**INFORMAL REFERRAL COMMENTS – DA 090/M005/18
248-252 UNLEY ROAD UNLEY**

Demolition of existing building structures, removal of two significant and one regulated tree. Construct six, two storey residential dwellings and a seven storey mixed use building containing five commercial tenancies, residential apartments, landscaping, ancillary car parking and associated building work.

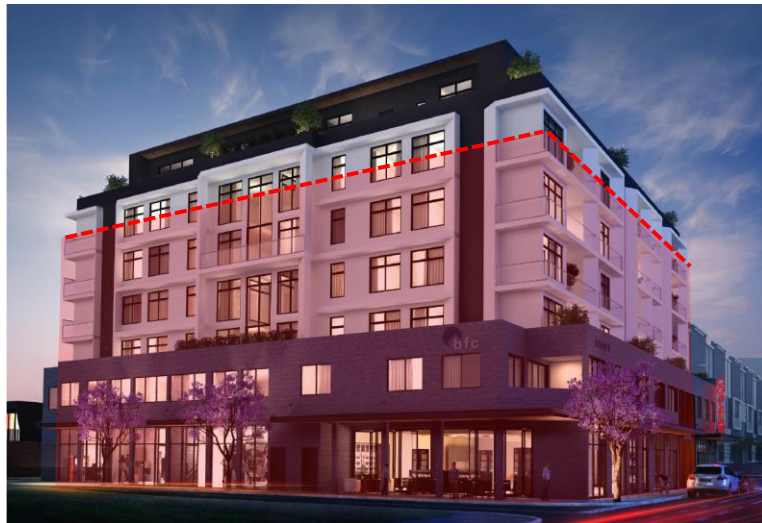
- Height to seven (7) storeys (24.3 metres excluding roof services) versus policy of five (5) storeys (18.5 metres). Represents a significant variation over the total desired height by 5.8 metres and 131%. Apparent street wall height, to visible balcony not including top recessed level, is 21.5 metres or 116%, still a notable variation. Removal of a lower level or two would be more compatible and warranted, with recessed form at 6 storey (21.3 metres and 115% and street wall 18.3 metres and 99%) or 5 storey (18.1 metres and 98%);

Limited rear built form and mass is positive and that the whole built form and extra tower height is contained within the fundamental zone boundary transition interface building envelope;

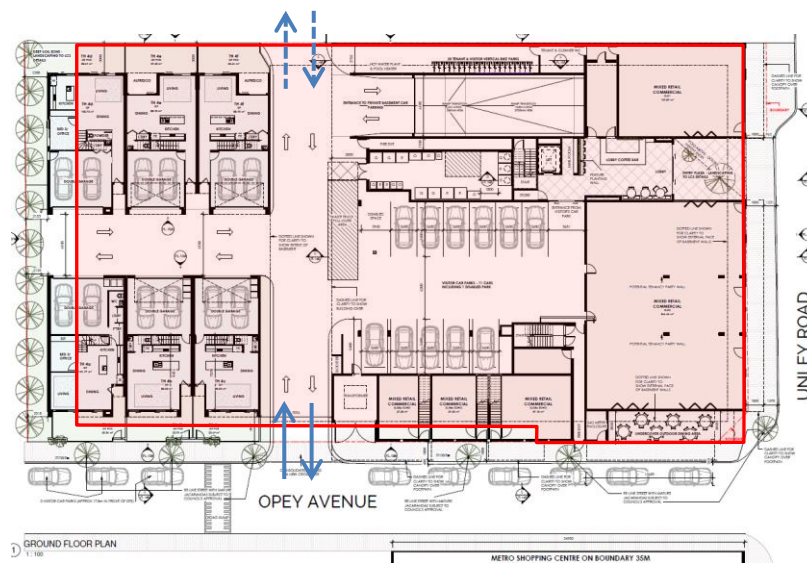
Along the secondary street frontage of Opey Avenue a 2.0 metre setback from 20.0 metres from the Unley Road alignment should be provided, whereas the 0.0 metres setback extends for some 36 metres. A setback would further soften the Opey Avenue built form and allow for additional landscaping to this part of the streetscape.

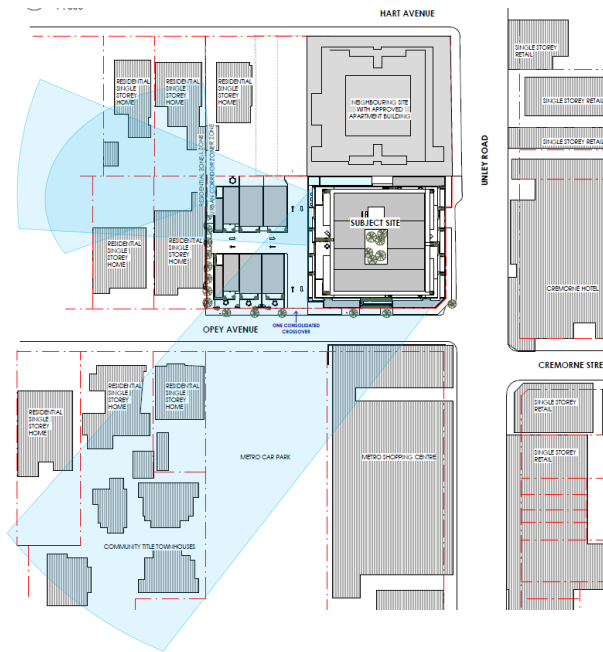
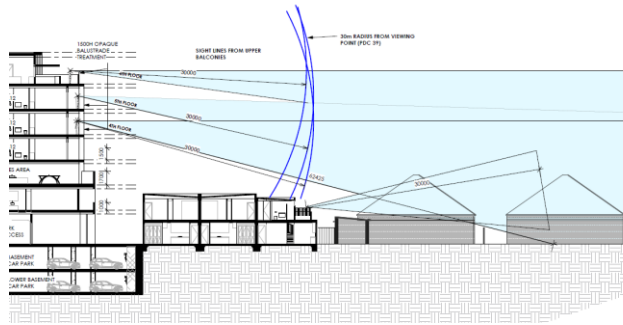
- One two-way accessway (tenant/resident and visitors) is provided to Opey Avenue. This consolidates and replaces two current accesses on Opey Avenue and one on Unley Road. This is positive and could realise an extra on-street car space on each frontage. Refer to Council section on broader on-street parking implications.
- It is indicated the accessway through the site will line-up and afford movement through the adjoining site to the north, and vice-a-versa, to improve on-site movements. This is very beneficial but should be reinforced in the development by conditions ensuring accord with approved designs and preferably a reciprocal Encumbrance or Land Management Agreement;

- Required configuration for Opey Avenue that can appropriately accommodate increased traffic movements and frequency of large waste vehicles leads to a need for loss of current on-street parking on one side of the street adjacent to the site. This makes level of on-site parking more critical;
